Figure 3
 Programmed Roadway Improvements in the Study Area
 Villages of San Carlos DRI – Time Extension Traffic Study
 Revised August 2006

LCDOT Sufficiency Checklist

Lee County Sufficiency Checklist for Planned Developments, Amendments, and Existing Developments Requesting Planned Development Zoning

CURRENTLY APPROVED
MASTER CONCEPT PLAN
FOR
VILLAGES OF SAN CARLOS
BY
WEST FLORIDA CAPITAL CORP.

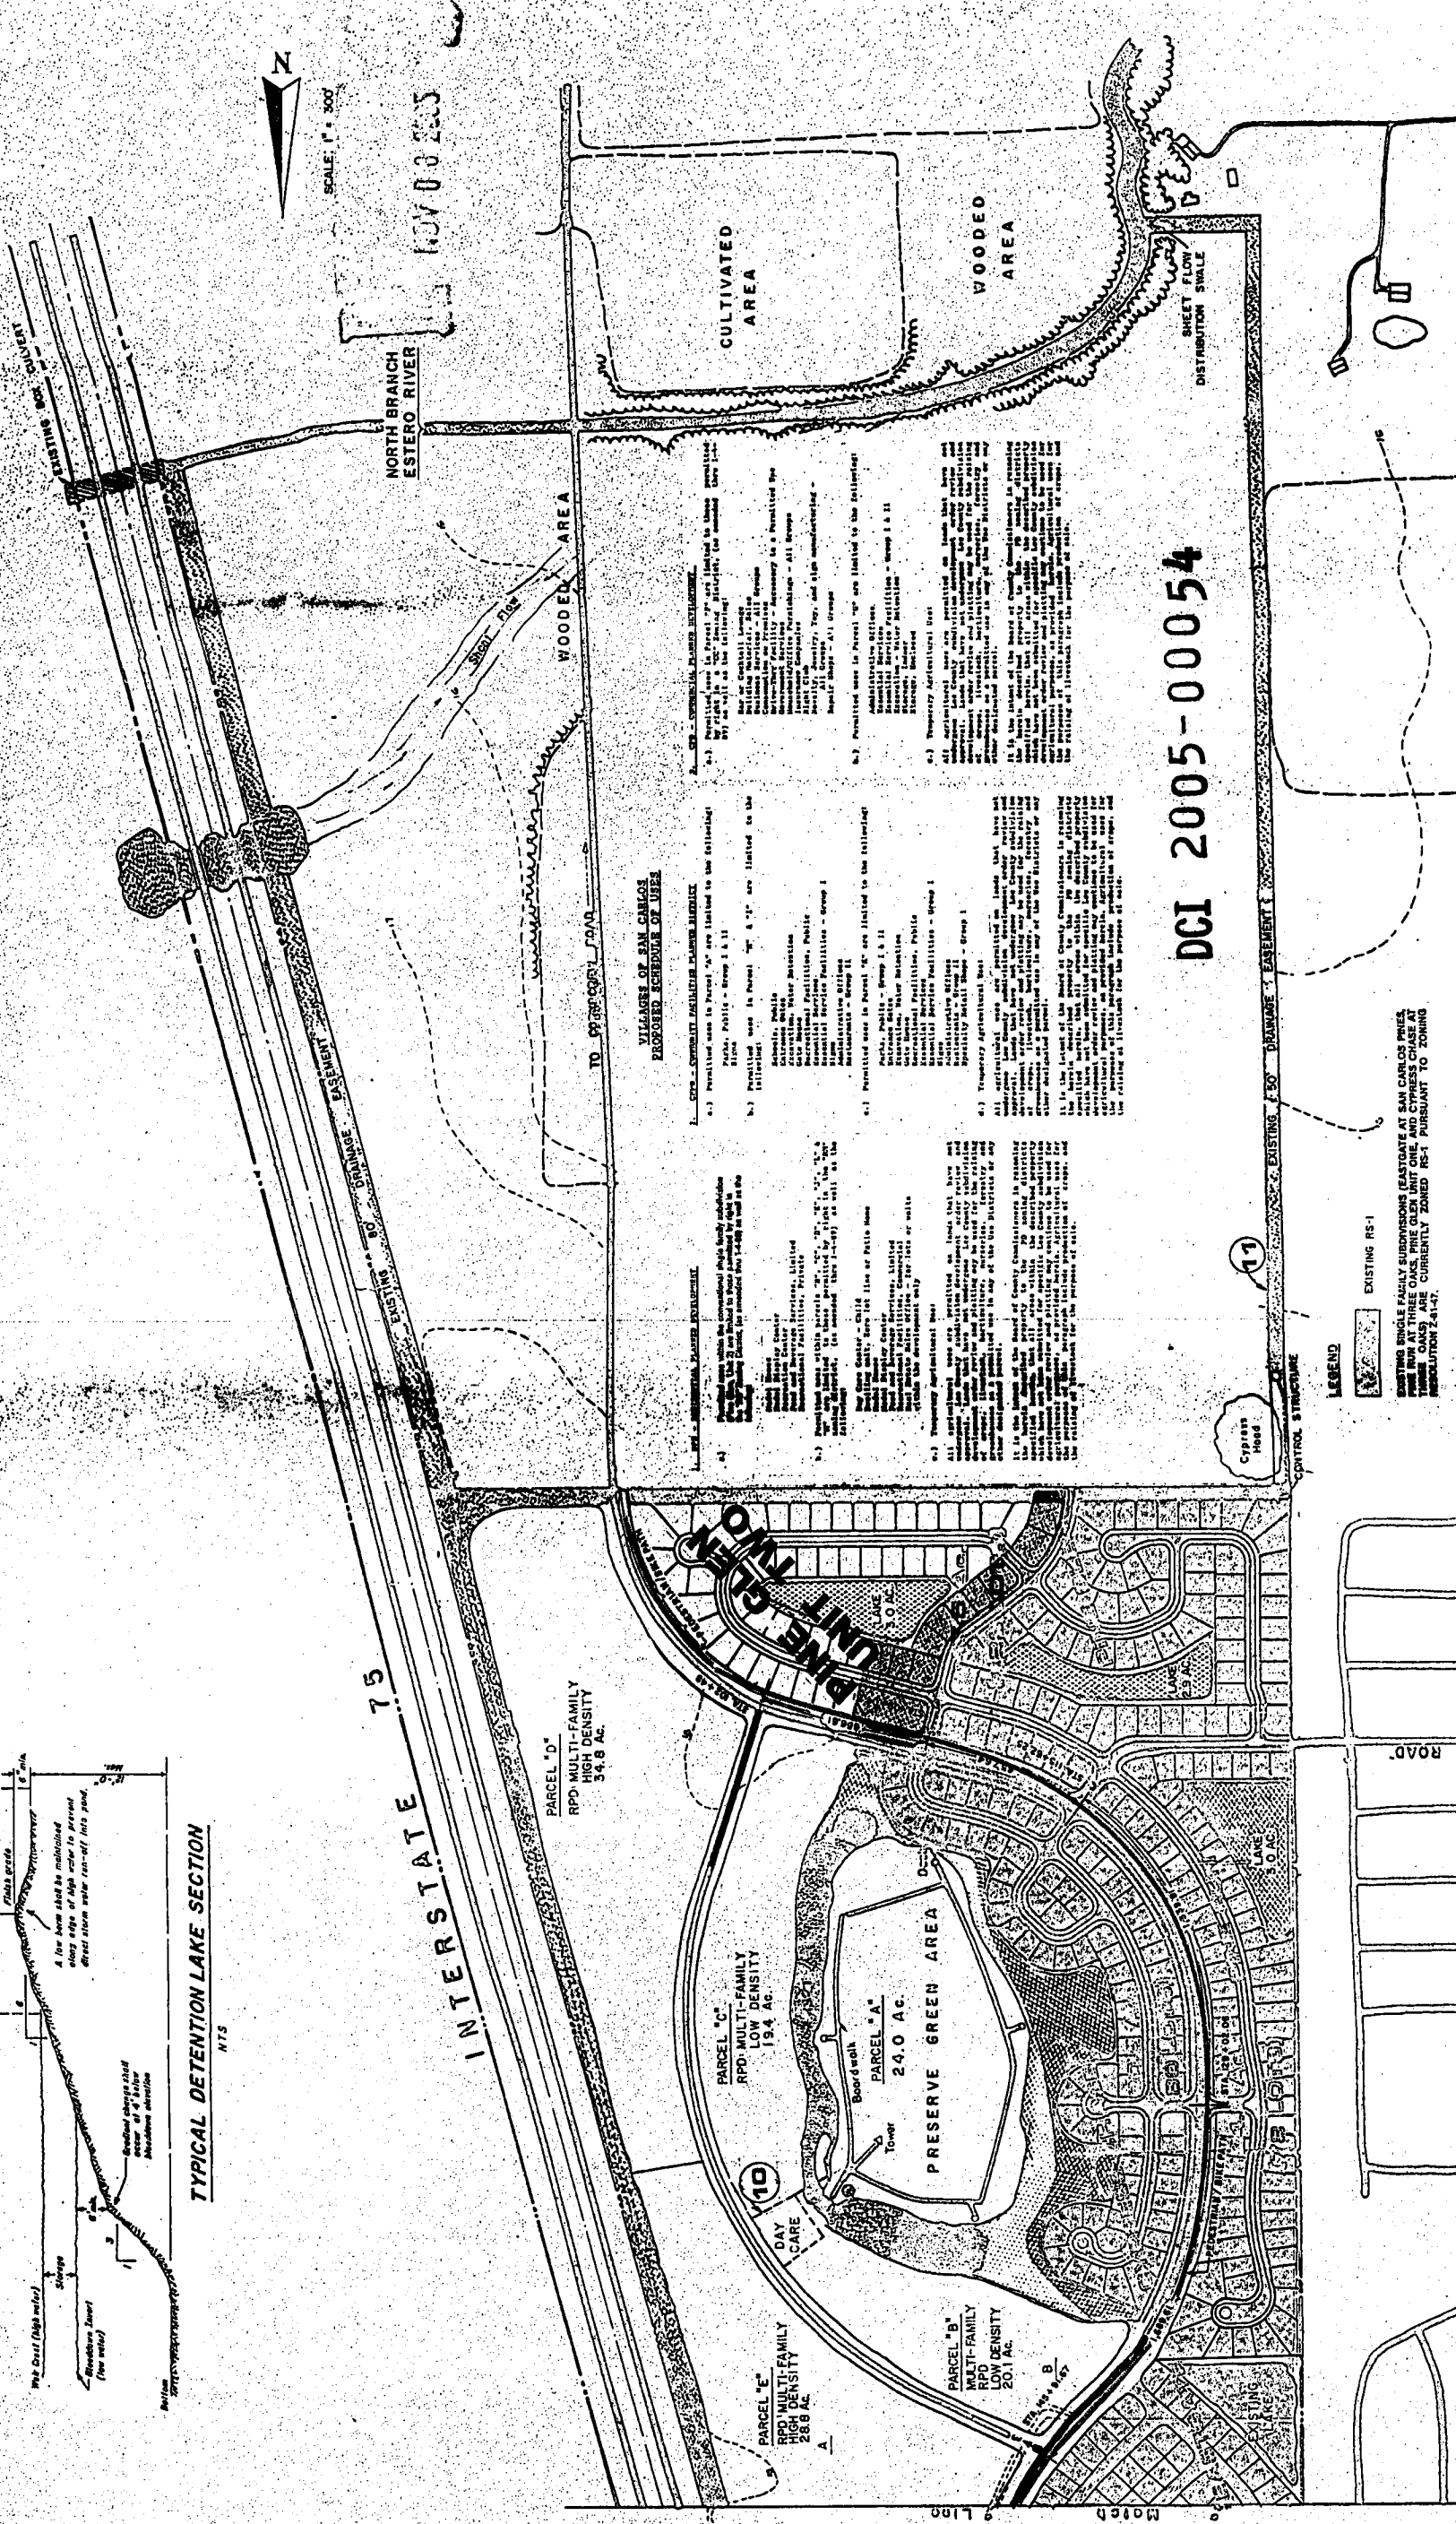
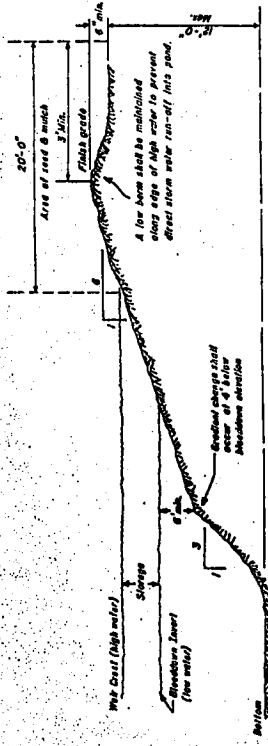
The proposed Schedule of Uses are Shown on Sheet C2. The Schedule of Uses must be deleted from the Sheet C2. (This is a duplication of the Schedule of Uses shown on Sheet B2).

Sheet C1 list all the deviations. These should be deleted from Sheet C1. Also, Determination requests should be deleted from Sheet C1 (See sufficiency Item 17, below).

Sheet C1 has a Table entitled Determination Requests. This should be deleted from Sheet C1. If the applicant is requesting waivers from sections of the LDC as shown in the Determination Requests Table, Sheet C1, then the applicant must submit under separate letter head a request for waivers to the Director of Zoning. The application will not be found sufficient until a response is resubmitted as part of the sufficiency review.

- G. Sheet C2, Under Notes, the first paragraph reads: "Refer to Sheet C1, Table B-1 for changes in the master concept plan indicated by the circled numbers" This is not clear, since there are two sets of circled numbers. Please clarify.

The second paragraph reads: "Refer to Sheet B1 for a List of Deviations from appropriate provisions of the Lee County zoning and development codes and ordinances". This is not necessary, please delete this note.

Exhibit C-1 (which includes sheets C1 & C2) is the currently approved MCP. The only change that we feel is appropriate to make to that exhibit is that of the "exhibit number" and the label that references it as the "previously approved MCP".

Exhibit C-1 (which includes sheets C1 & C2) is the currently approved MCP. The only change that we feel is appropriate to make to that exhibit is that of the "exhibit number" and the label that references it as the "previously approved MCP".

Exhibit C-1 (which includes sheets C1 & C2) is the currently approved MCP. The only change that we feel is appropriate to make to that exhibit is that of the "exhibit number" and the label that references it as the "previously approved MCP".

The referenced note is left over from when the current Exhibit C-1 (sheets C1 and C2) had been Exhibit B-1 from the zoning exhibit plan set approved with Resolution Z-91-083. They are referring to the changes that had been made at that time from the "original" MCP. They mean nothing to this application. As stated previously, Exhibit C-1 (which includes sheets C1 & C2) is the currently approved MCP. The only change we felt appropriate to make to that exhibit was that of the "exhibit number" and the label that references it as the "previously approved MCP".

The referenced note is left over from when the current Exhibit C-1 (sheets C1 and C2) had been Exhibit B-1 from the zoning exhibit plan set approved with Resolution Z-91-083. They are referring to the changes that had been made at that time from the "original" MCP. They mean nothing to this application. As stated previously, Exhibit C-1 (which includes sheets C1 & C2) is the currently approved MCP. The only change we felt appropriate to make to that exhibit was that of the "exhibit number" and the label that references it as the "previously approved MCP".
